**NEW YORK STATE THRUWAY AUTHORITY
DEPARTMENT OF ENGINEERING**

**ALBANY, NY
FEBRUARY 8, 2024**

**AMENDMENT NO. 1
TO**

**CONTRACT TANY 24-8
D214964
2" MILL AND INLAY, SAFETY
IMPROVEMENTS AND MISCELLANEOUS WORK
BETWEEN MILEPOST 47.6+/- AND MILEPOST 60.1+/-
IN THE NEW YORK DIVISION
OF THE NEW YORK STATE THRUWAY
IN ORANGE COUNTY**

TITLE OF PROJECT PAYMENT RESURFACING AND SAFETY IMPROVEMENT	CONTRACT NUMBER: TANY 24-8
LOCATION OF PROJECT NY DIVISION MP 48.0 TO 60.1	DATE: 1/2024
TITLE OF DRAWING GENERAL PLAN	DRAWING NUMBER: GP-17

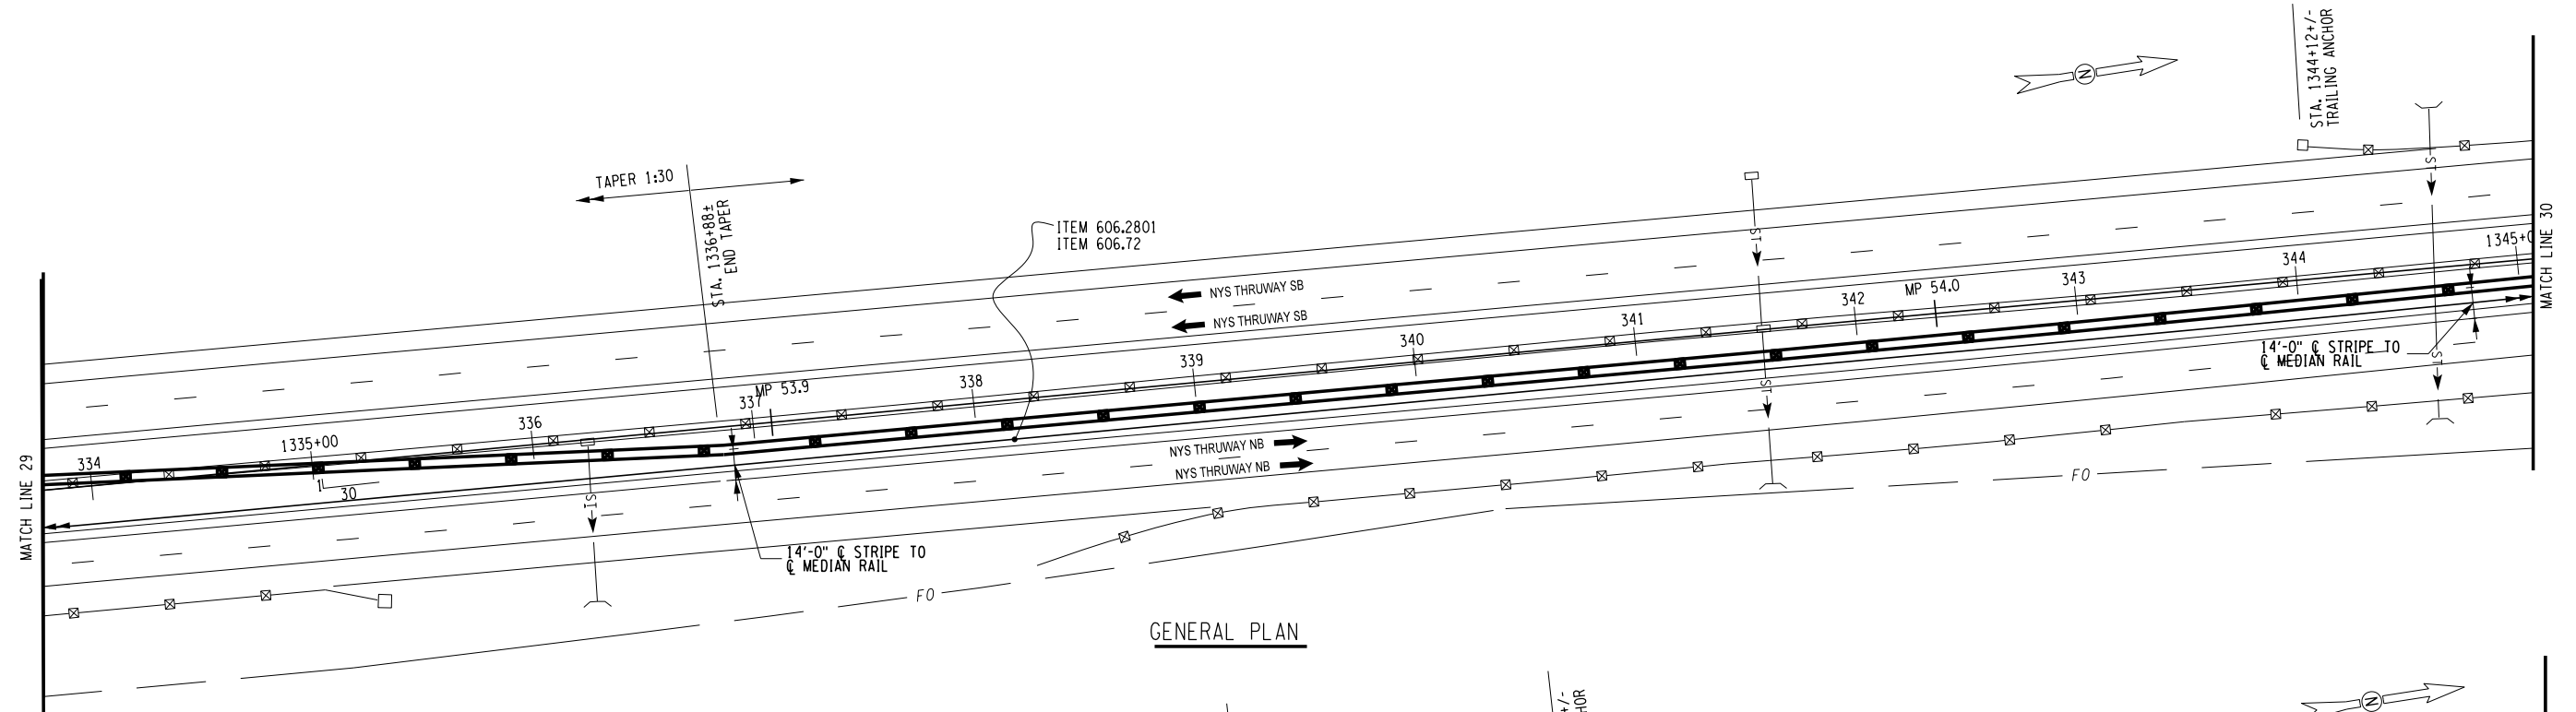
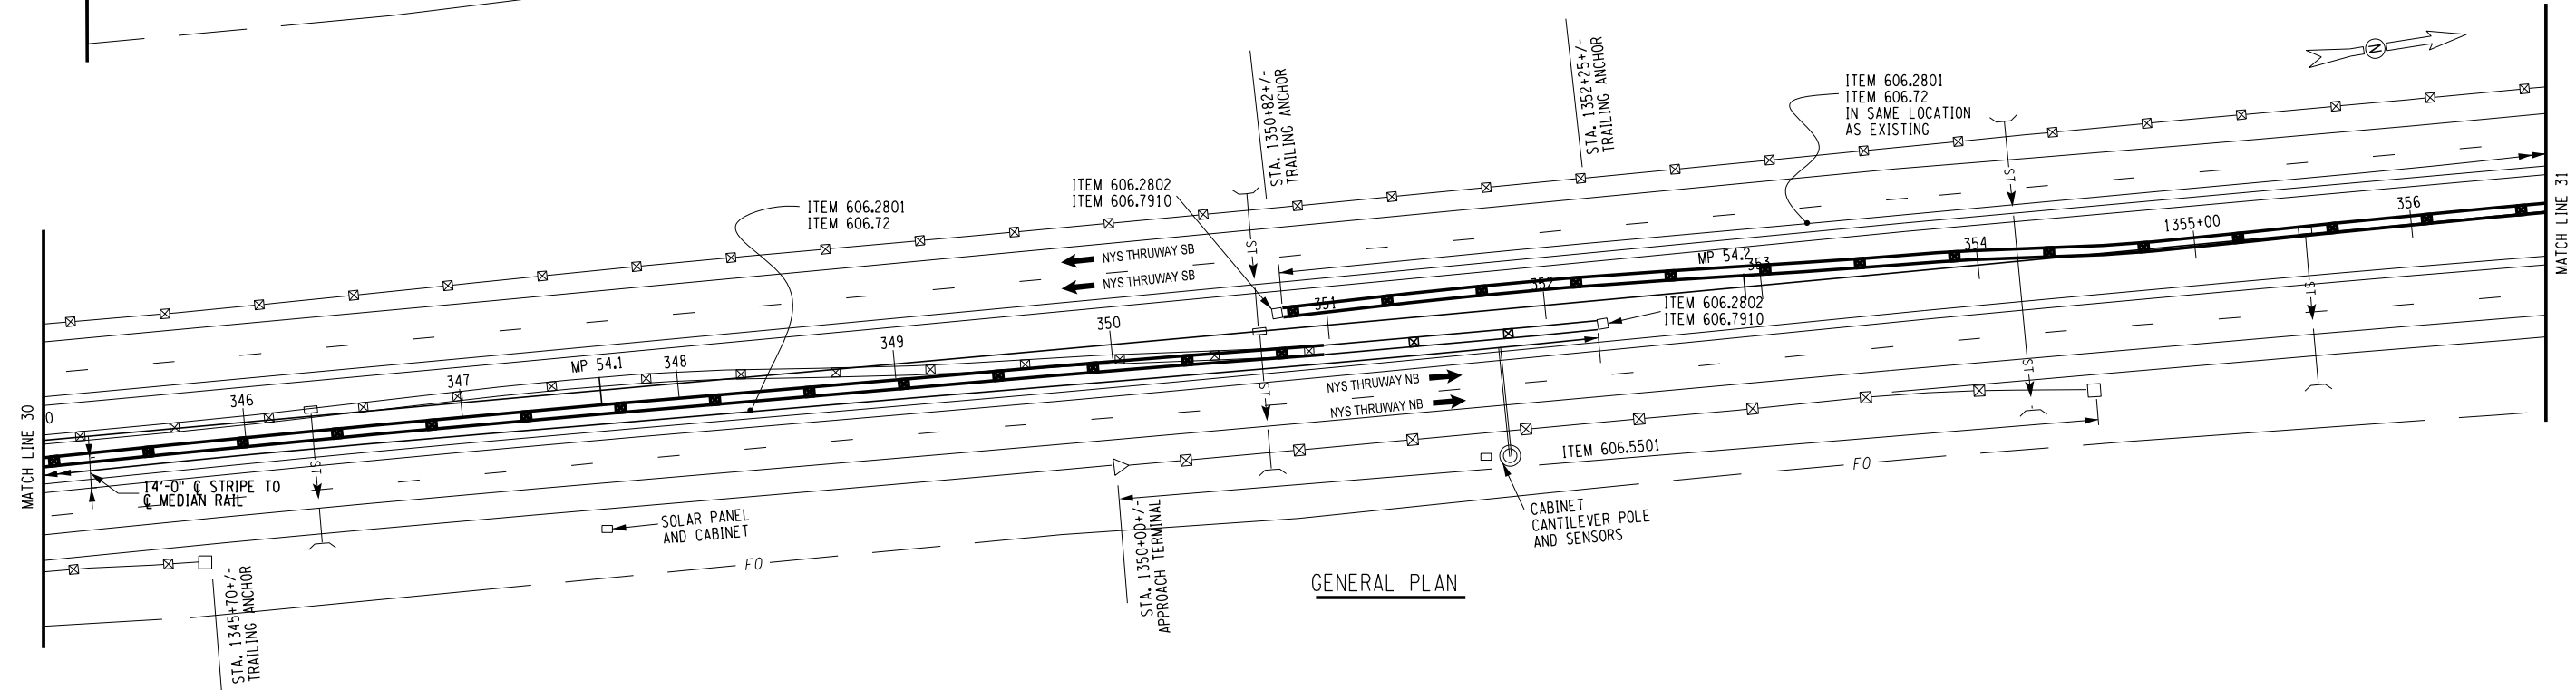
22. **DELETE** Drawing Number GP-17, Sheet 88 of 108, and **SUBSTITUTE** with the attached Drawing Number GP-17, Sheet 88-A1 of 108. Changed proposed median rail from existing to proposed line weight.

TITLE OF PROJECT PAVEMENT RESURFACING AND SAFETY IMPROVEMENT	CONTRACT NUMBER: TANY 24-8
LOCATION OF PROJECT NY DIVISION MP 48.0 TO 60.1	DATE: 1/2024
TITLE OF DRAWING GENERAL PLAN	DRAWING NUMBER: GP-18

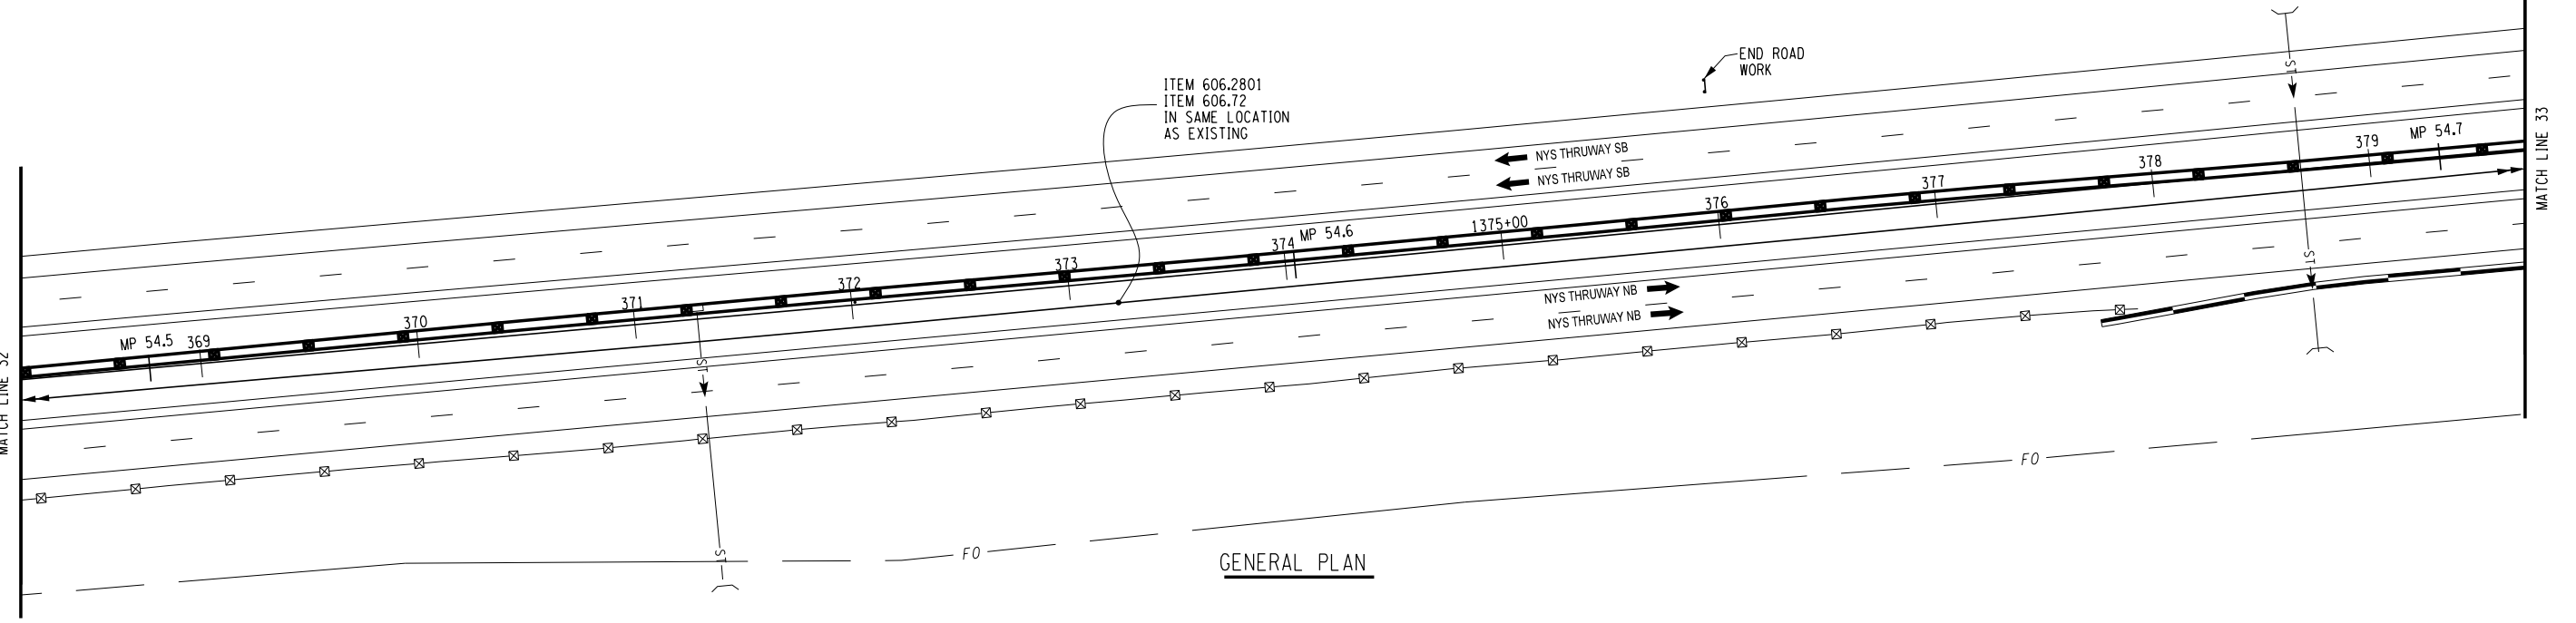
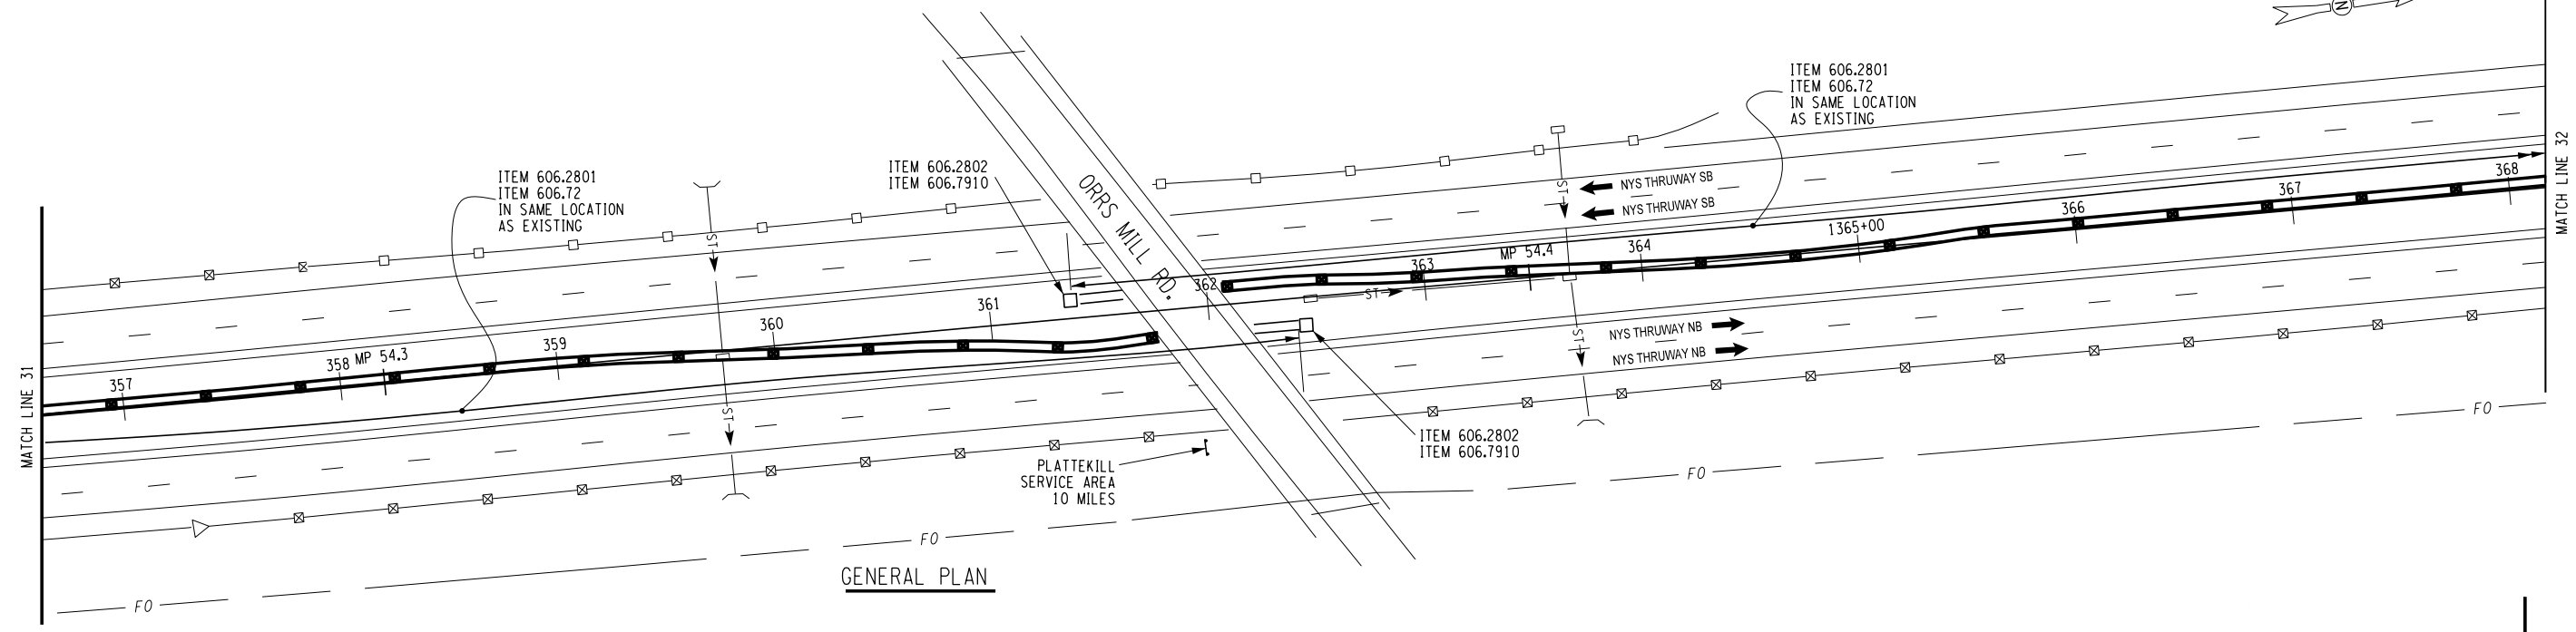
23. **DELETE** Drawing Number GP-18, Sheet 89 of 108, and **SUBSTITUTE** with the attached Drawing Number GP-18, Sheet 89-A1 of 108. Changed proposed median rail from existing to proposed line weight.

DRAWING NUMBER: GP-19

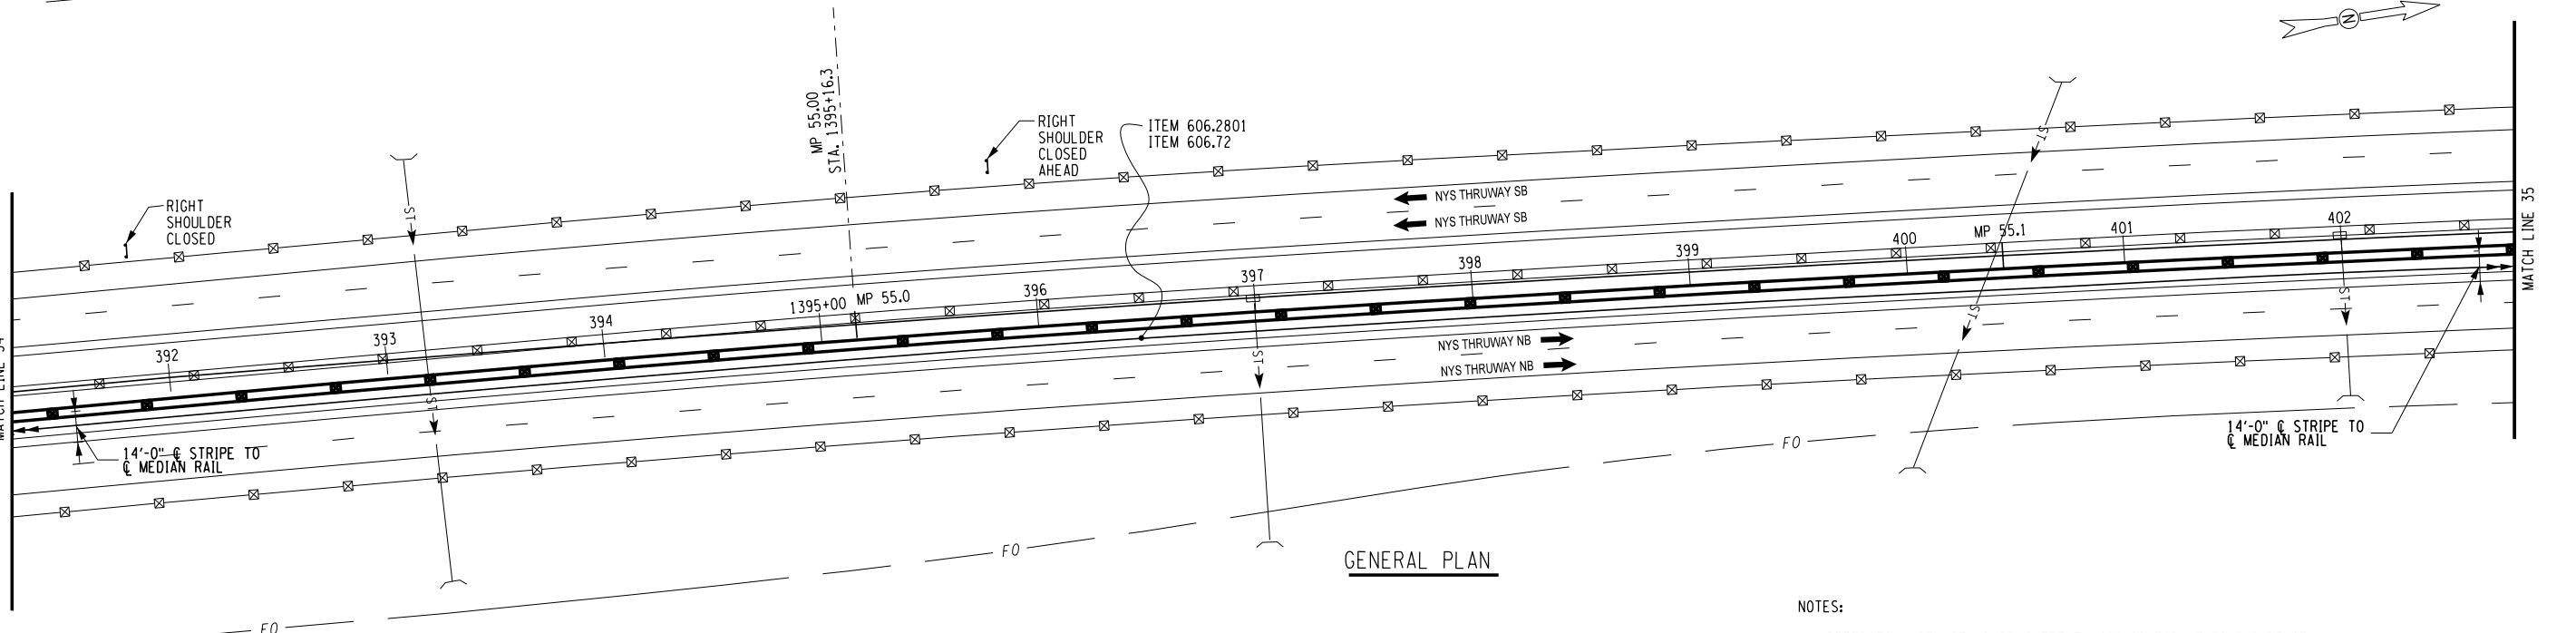
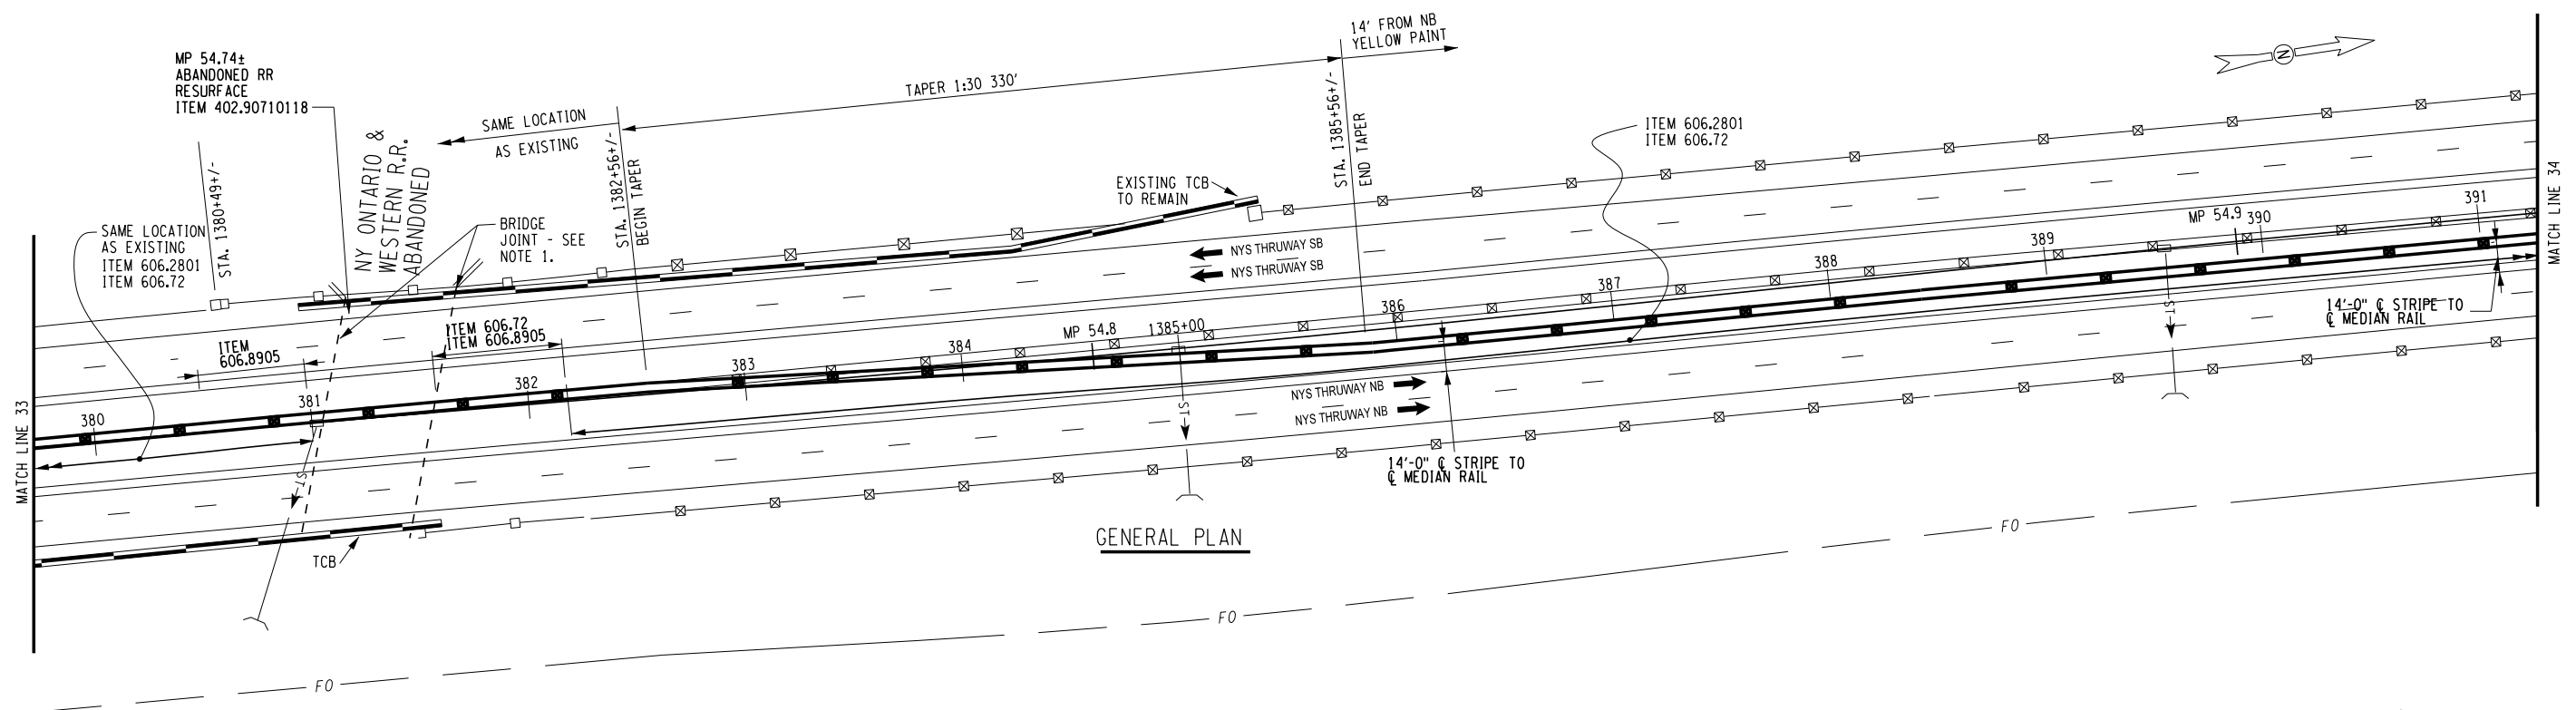
24. **DELETE** Drawing Number GP-19, Sheet 90 of 108, and **SUBSTITUTE** with the attached Drawing Number GP-19, Sheet 90-A1 of 108. Added location of proposed rail from matchline 33 to sta. 1382+56+/- . Changed proposed median rail from existing to proposed line weight.
